Botley West Solar Farm

Change Request 2: Consultation Report

PINS Ref: EN010147

Document Ref: EN010147/APP/16.4

Appendix 1 - Change 1

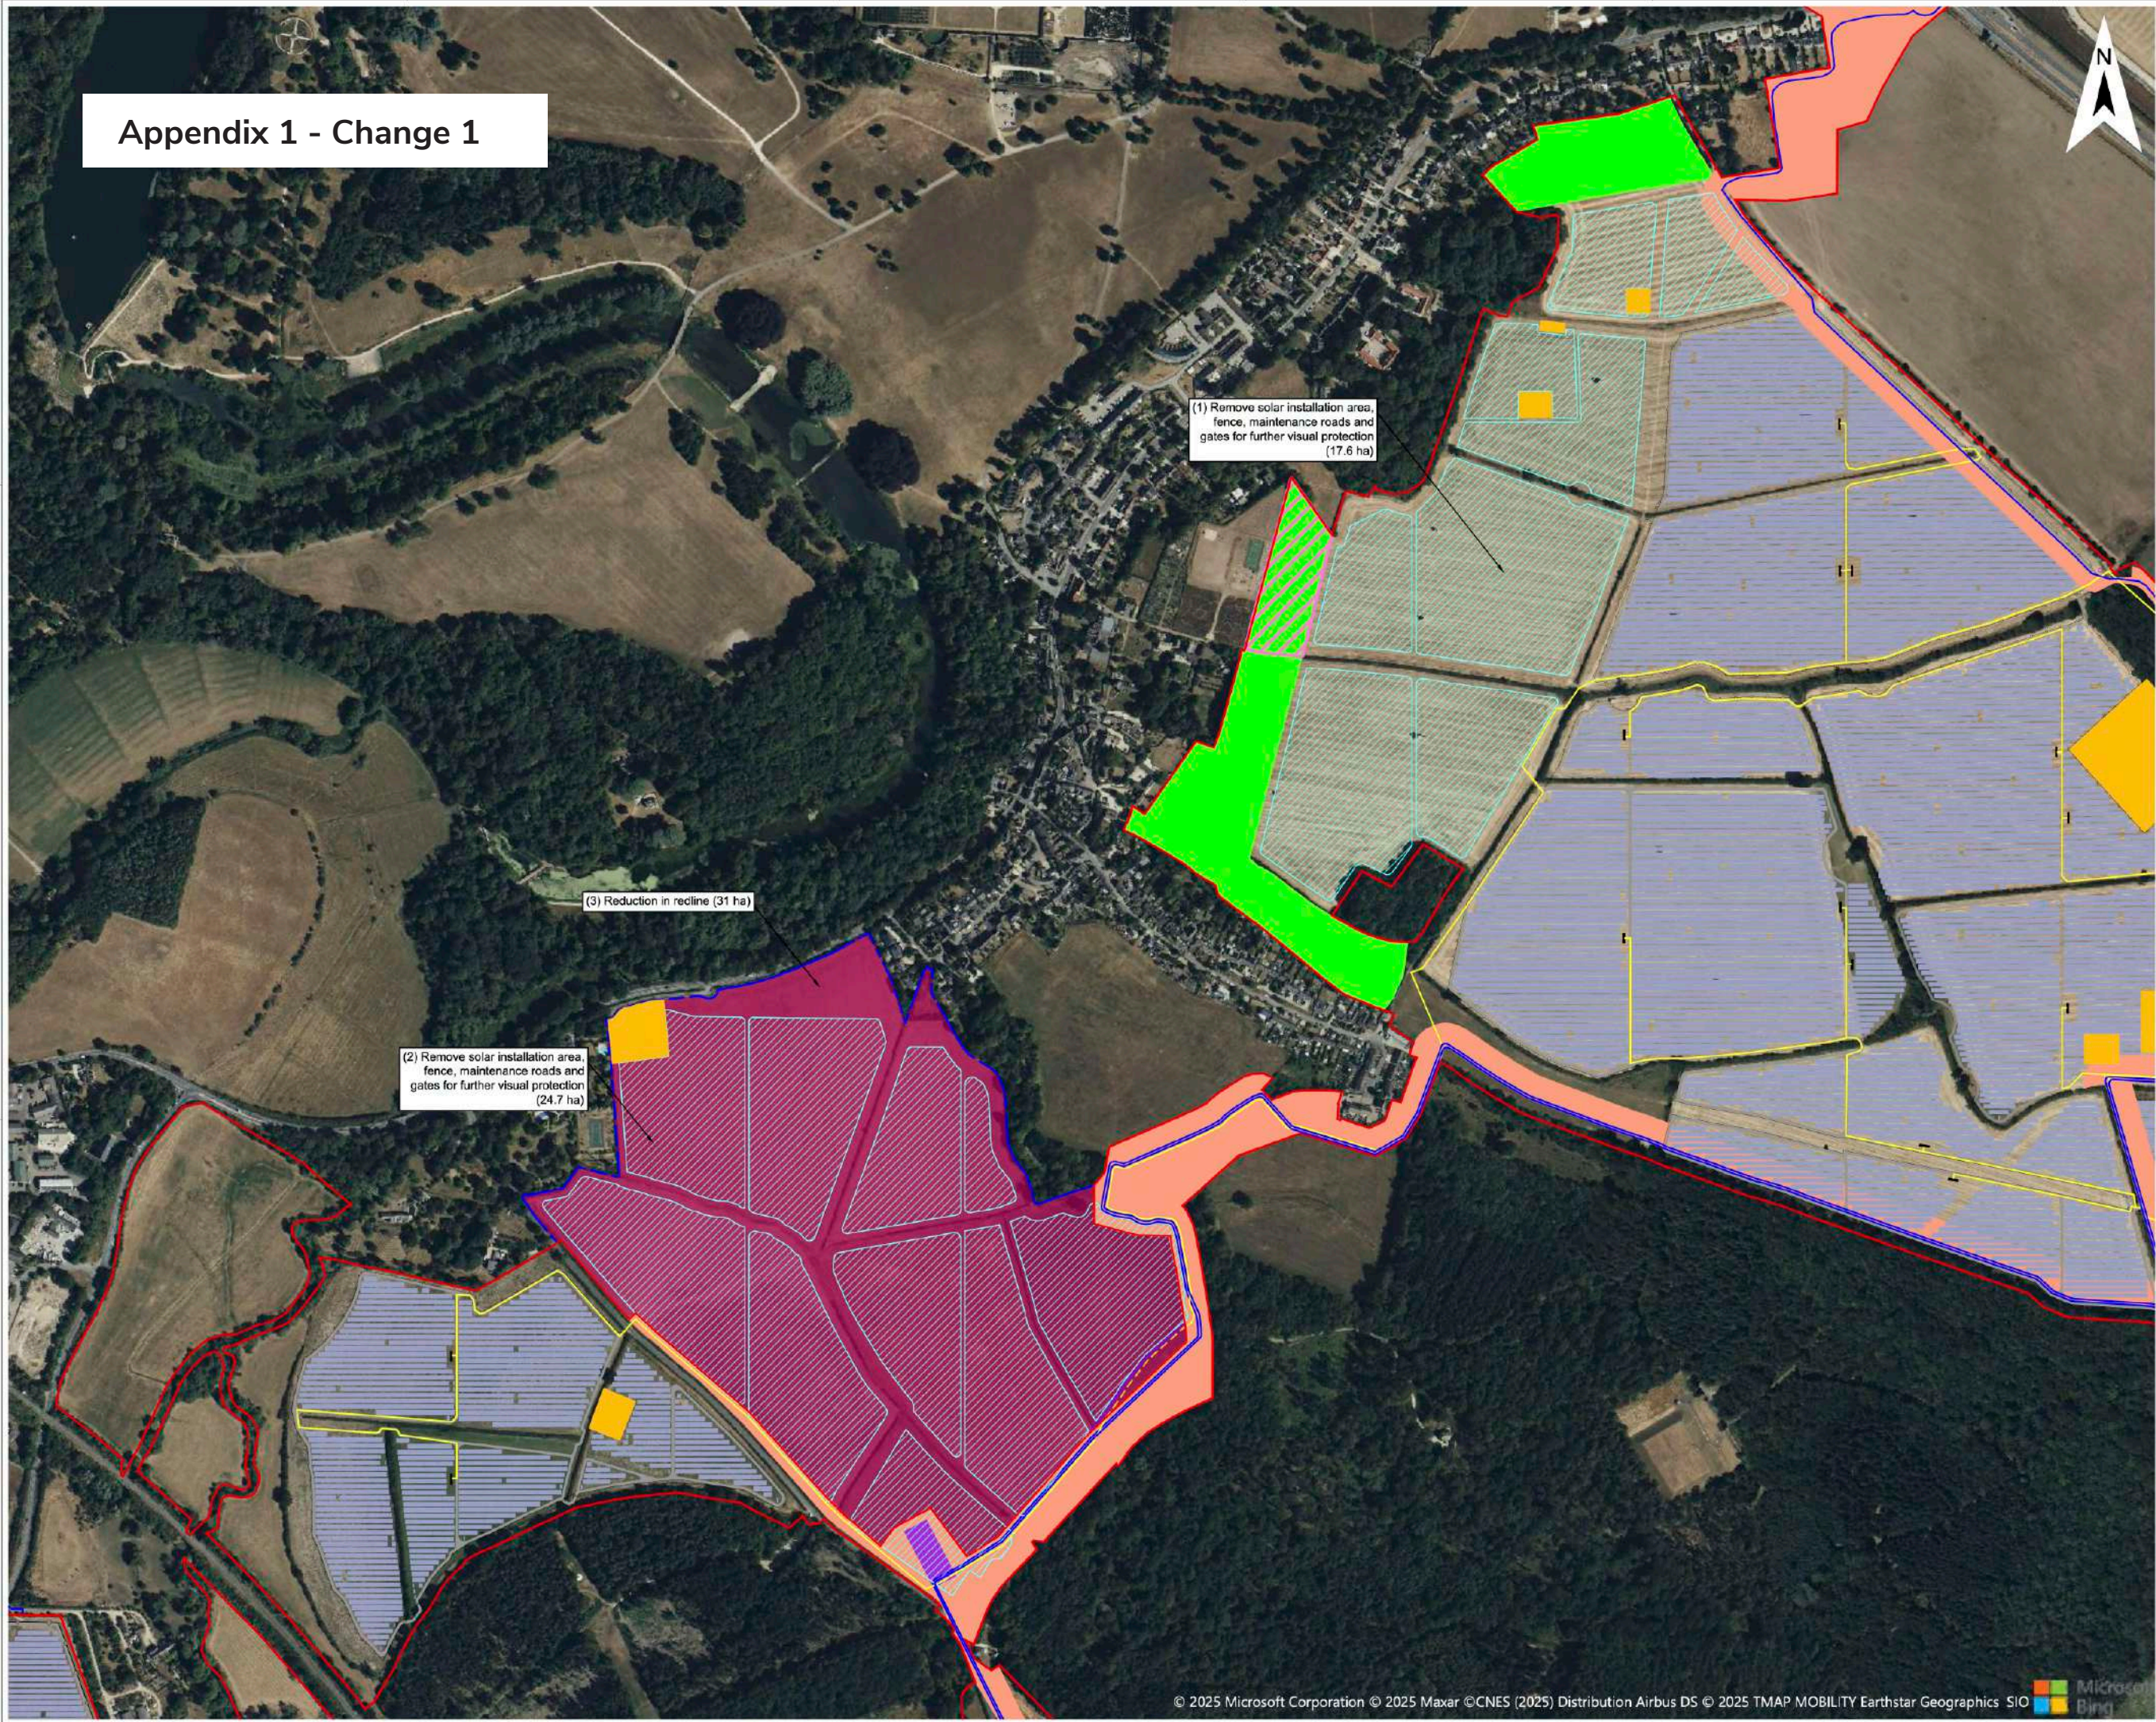
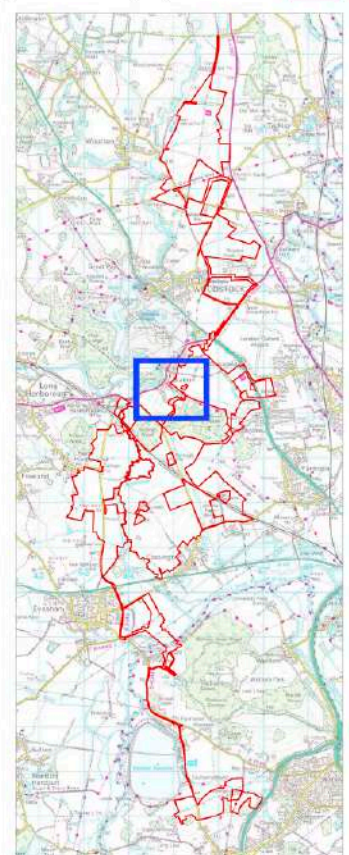
Change 1: Reduction in Order Limits boundary to reduce the solar installation area south-west of Bladon and removal of solar arrays on land south-east of Bladon and north of Heath Lane (see Appendix A attached to the Notification)

The primary purpose of this proposed change is to protect the setting of the Blenheim Palace World Heritage Site, in response to feedback received from Interested Parties including Historic England. In their Written Representation [REP1-086], Historic England advised that *'further refinements could avoid much of the harm to the WHS, Blenheim Palace listed building and Registered Park and Garden, by removing solar panel development from the fields marked 2.1, 2.2, 2.5 and 2.20-2.26'* (paragraph 5.56). These changes are being sought to address those concerns expressed by Historic England and comprise the full removal of all solar panels and associated infrastructure from those fields identified by Historic England in its Written Representation.

Title: Change Request 2
Notification - Change 5

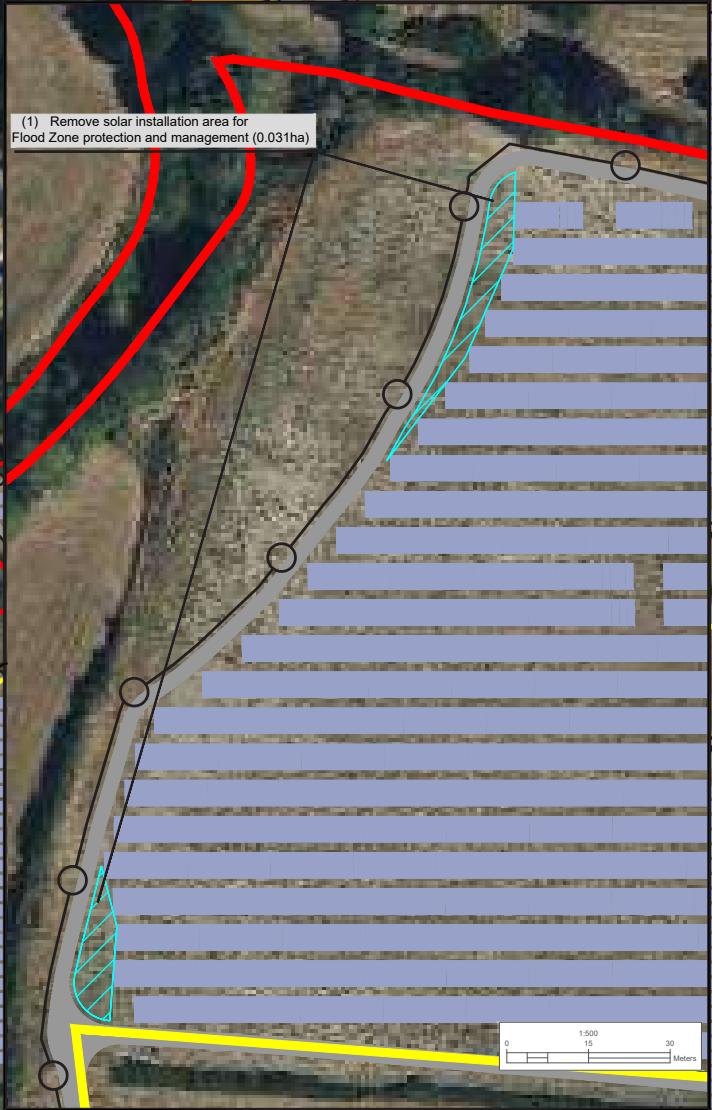
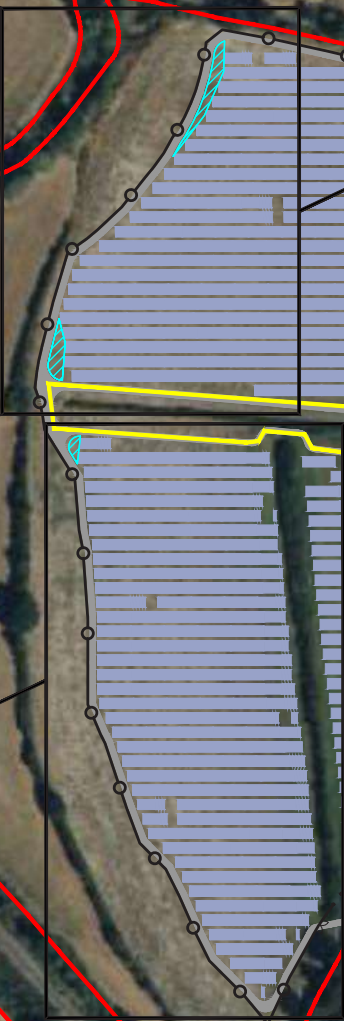
Change 5: Refinement of Project layout and design to remove installation areas overlapping with Flood Zones 2 and 3 (see Appendix A attached to the Notification)

As a result of a base mapping error, the Applicant has identified minor anomalies where the solar installation slightly overlaps with Flood Zone 2 or 3 throughout the Project site. The Applicant is committed to not develop within Flood Zone 2 or 3 and so is proposing to correct this mapping anomaly. This has resulted in a small loss of installation area in several locations amounting to approximately 0.72 ha.

Appendix 6 - Change 6

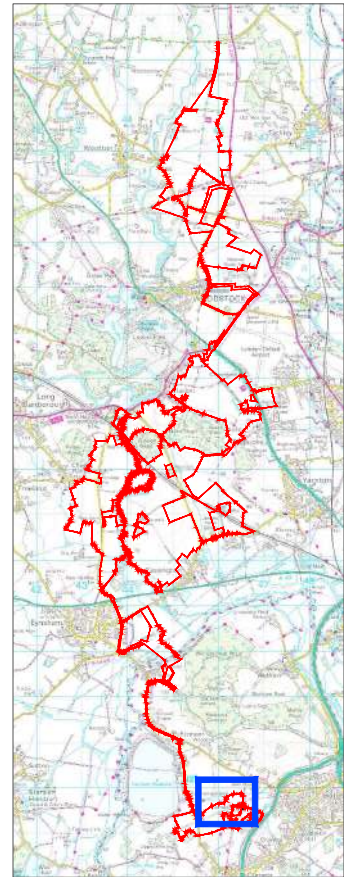
Change 6: Refinement of Project layout and design to include an additional installation area within Southern Site (see Appendix A attached to the Notification)

The Applicant has recently become aware of a change in the EA mapping of parts of Flood Zone 2. In particular, an area within the Order Limits was previously excluded from development because it was within Flood Zone 2. This is an area of approximately 2.41 ha, within the Southern Site. The Applicant now wishes to utilise this area for additional solar array as a result of the change in Flood Zone status.
